JAMES A. FITZPATRICK NUCLEAR POWER PLANT

AMENDMENT TO FACILITY OPERATING LICENSE

Amendment No. 49
License No. DPR-59

ATTACHMENT TO LICENSE AMENDMENT NO. 49

FIGURE 3.5-7 MAXIMUM AVERAGE PLANAR LINEAR HEAT GENERATION RATE (MAPLHGR) VERSUS PLANAR AVERAGE EXPOSURE

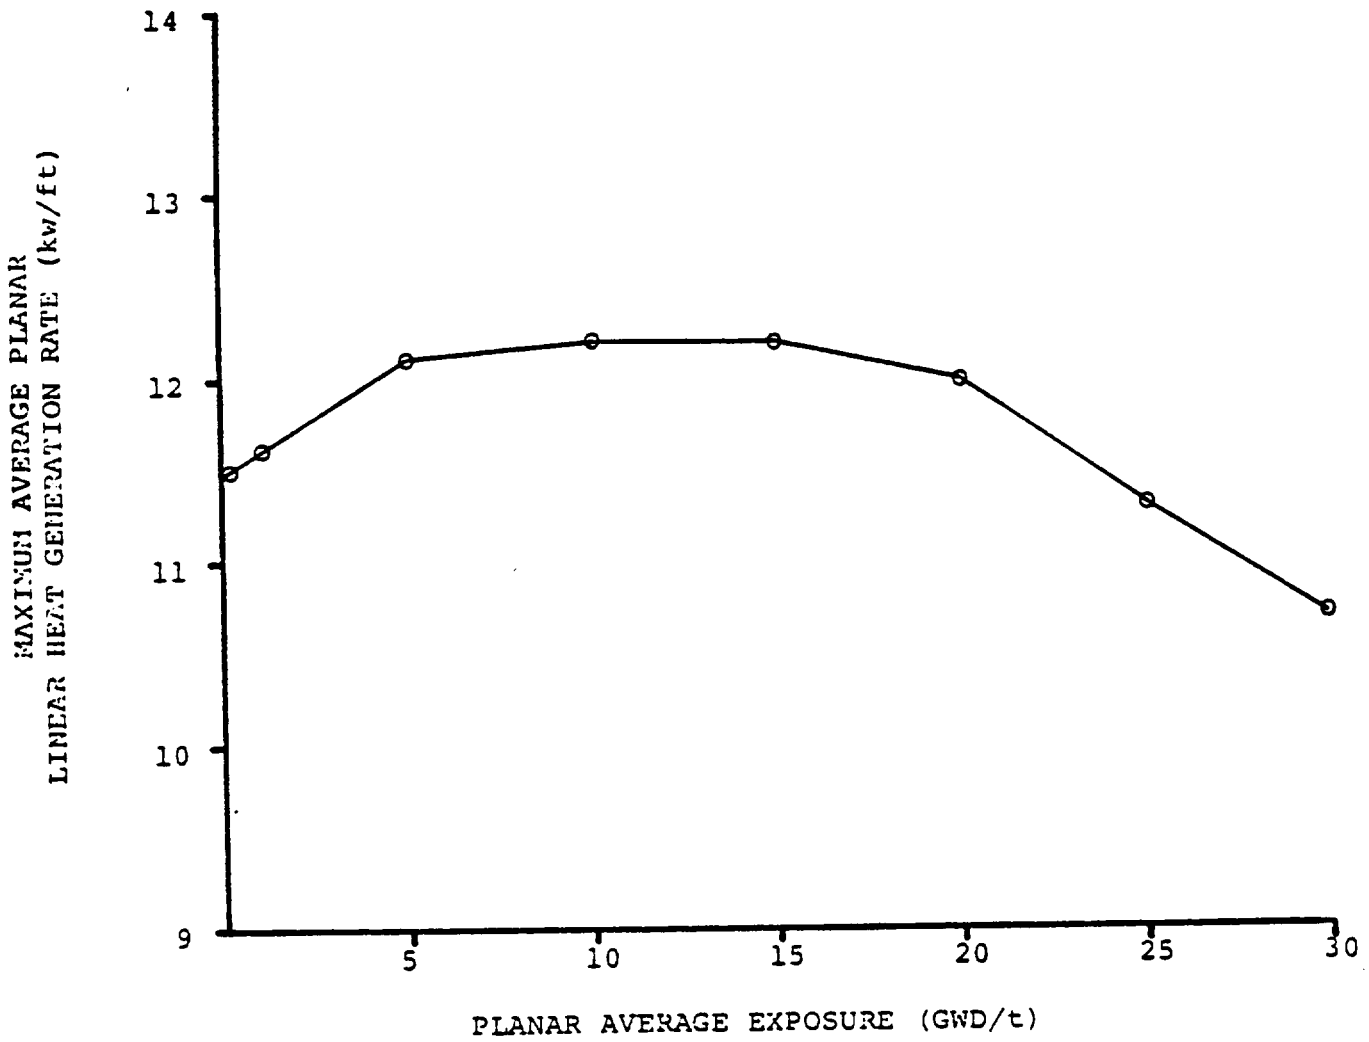
RELOAD 3, P8DRB265L

FULL CORE DRILLED

REFERENCE
NEDO-24242
SECTION 14

The APLHGR for each type of fuel as a function of average planar exposure shall not exceed the limiting value shown in Figures 3.5.1 through 3.5.8. If anytime during reactor power operation greater than 25% of rated power it is determined that the limiting value for APLHGR is being exceeded, action shall then be initiated within 15 minutes to restore operation to within the prescribed limits. If the APLHGR is not returned to within the prescribed limits within two (2) hours, an orderly reactor power reduction shall be commenced immediately. The reactor power shall be reduced to less than 25% of rated power within the next four hours, or until the APLHGR is returned to within the prescribed limits.

FIGURE 3.5-8 MAXIMUM AVERAGE PLANAR LINEAR HEAT RATE (MAPLHGR) VERSUS PLANAR AVERAGE EXPOSURE

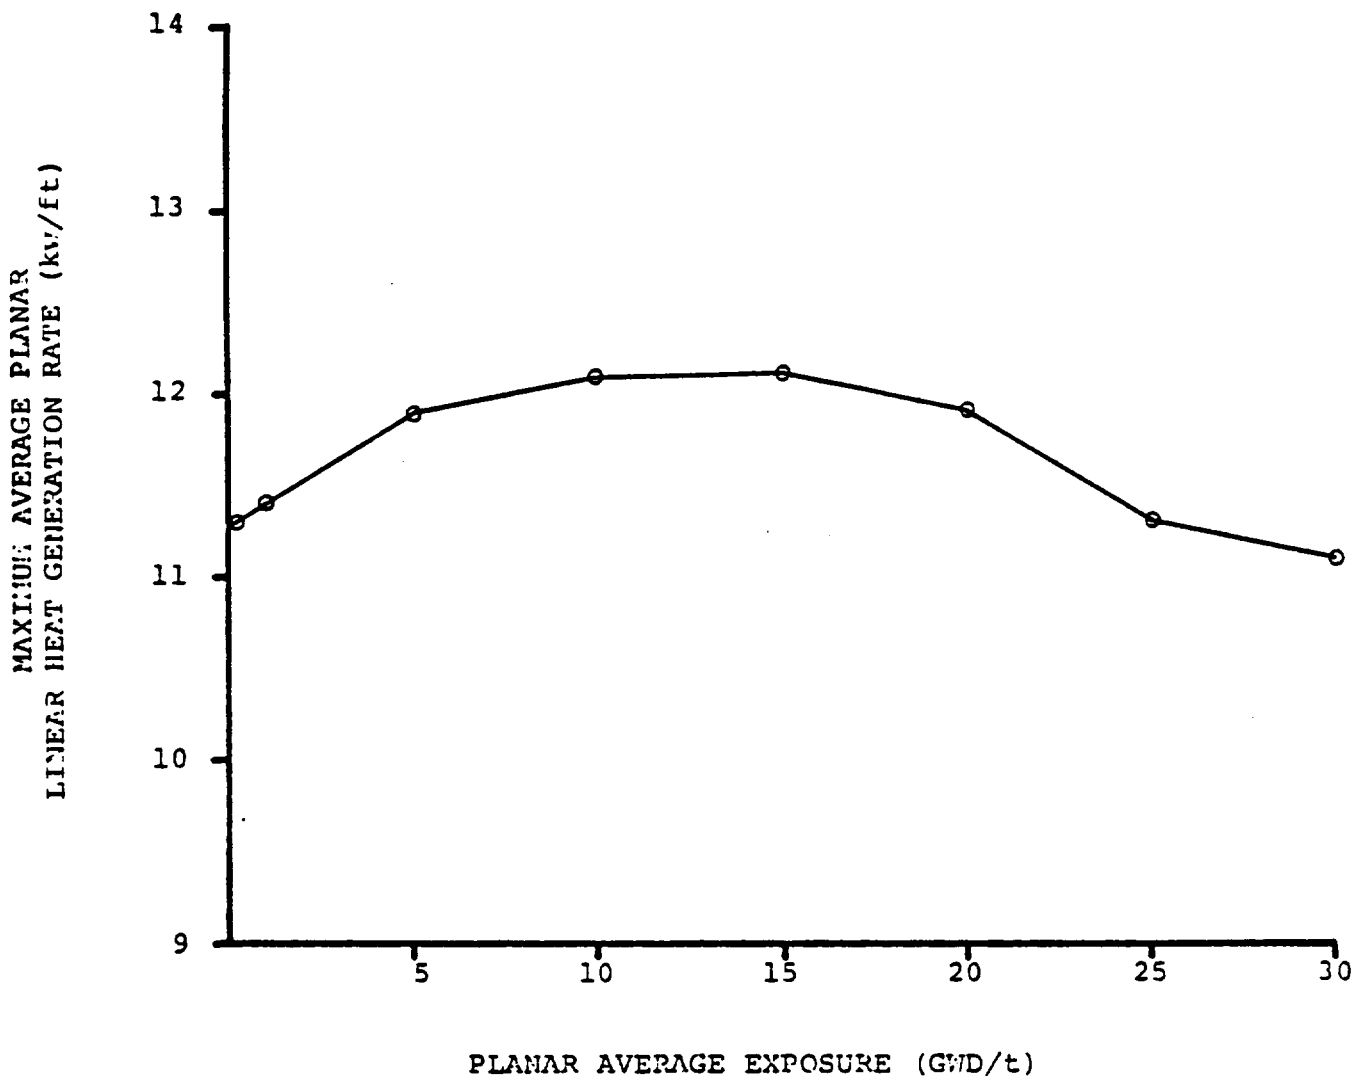
RELOAD 3, P8DRB283
